METROPOLITAN GOVERNMENT OF NASHVILLE AND DAVIDSON COUNTY

STAFF RECOMMENDATION
1208 Cedar Lane
December 17, 2014

Application: New construction - addition
District: Belmont-Hillsboro Neighborhood Conservation Zoning Overlay
Council District: 18
Map and Parcel Number: 11801009800
Applicant: Tyler LeMarinel, Allard-Ward Architecture
Project Lead: Sean Alexander, sean.alexander@nashville.gov

<p>Description of Project: The applicant proposes to construct a rear addition with a screened porch on the left side, wider than the historic house.</p> <p>Recommendation Summary: Staff recommends approval of the proposed addition with the conditions that Staff approves the final selection of the windows and doors, finding that the proposal meets the design guidelines for the Belmont-Hillsboro Neighborhood Conservation Zoning Overlay.</p>	<p>Attachments A: Photographs B: Site Plan D: Elevations</p>
---	--

1 Site Layout Plan
Scale: 1" = 20'-0"

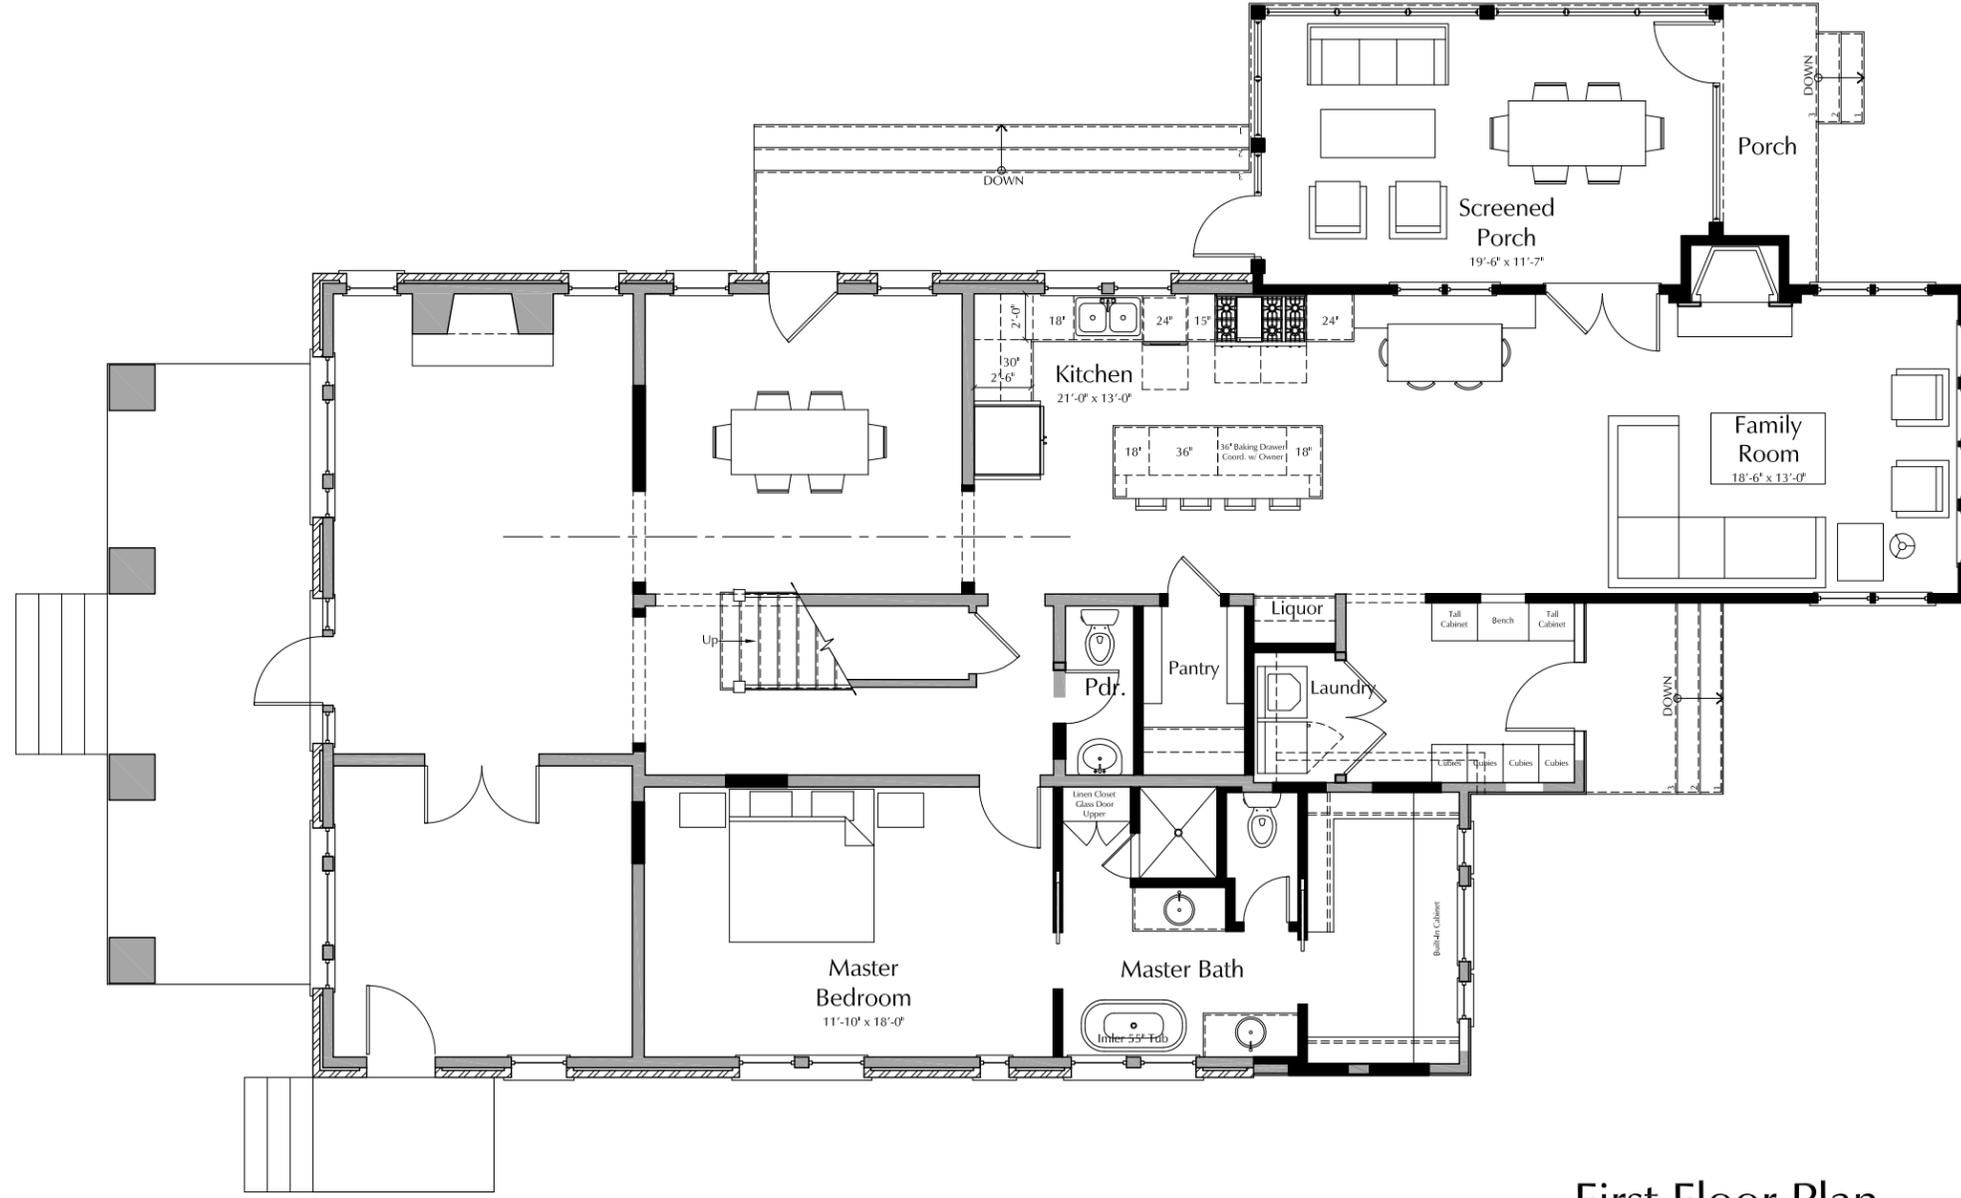
The left side of the screened porch will be five feet (5') in from the edge of the property. The front of the screened porch will be fifty feet (50') back from the front of the house, and ninety-seven feet from the front property line. Because the addition is so far back, it will not have a significant impact on the rhythm of spacing along the street. The addition will not have an impact on the front or right side setbacks. The project meets section II.B.1.c of the design guidelines.

1 First Floor Plan
 Scale: 1/8" = 1'-0"

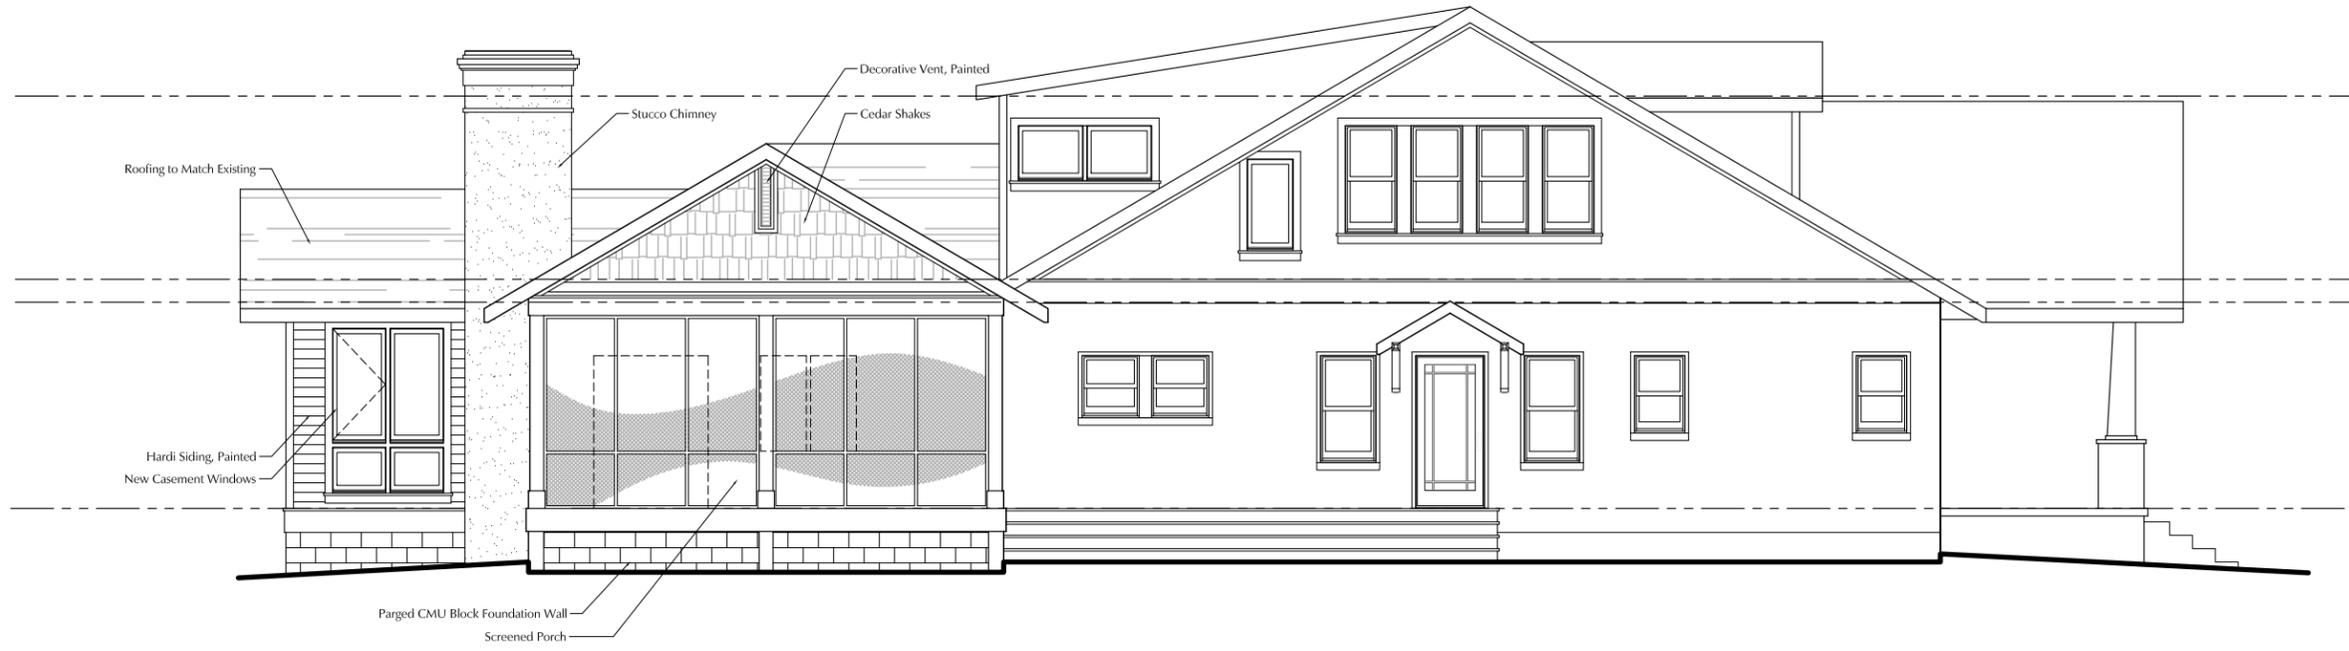
The new addition will incorporate portions of the side walls of the earlier addition, which are flush with the sides of the historic house. The new addition extends twenty-one feet (21') further to the rear, continuing to be flush with the left wall of the house and sitting in twenty-two feet (22') from the right side of the house. The roof of the addition will be a rear-facing gable with a ridge eight feet (8') below the peak of the historic house. Typically, additions have been required to sit in from both sides of an historic house in order to differentiate the new construction from the old. However, Staff finds in this case that it is not necessary to sit the addition in because the house's current addition is flush with the sides of the house and this addition will be replacing that condition.

The screened porch will originate at the rear-left corner of the historic house, extending twelve feet (12') to the left and twenty-one feet (21') to the rear. The width of the addition is roughly one-third of the historic house. The porch will not impact the sides of the historic house as it to the rear and along the left side of the new rear addition. The porch will have a gabled roof projecting to the side, with a ridge six feet (6') below the ridge of the historic house. Typically, it is not appropriate for additions to be wider than an historic house; however, in this case Staff finds that it is appropriate because the lot is seventy feet (70') wide and the house is only thirty-five feet (35') wide. Section II.B.2.b allows for a side addition on an historic house when it is on a lot that exceeds 60 in width.
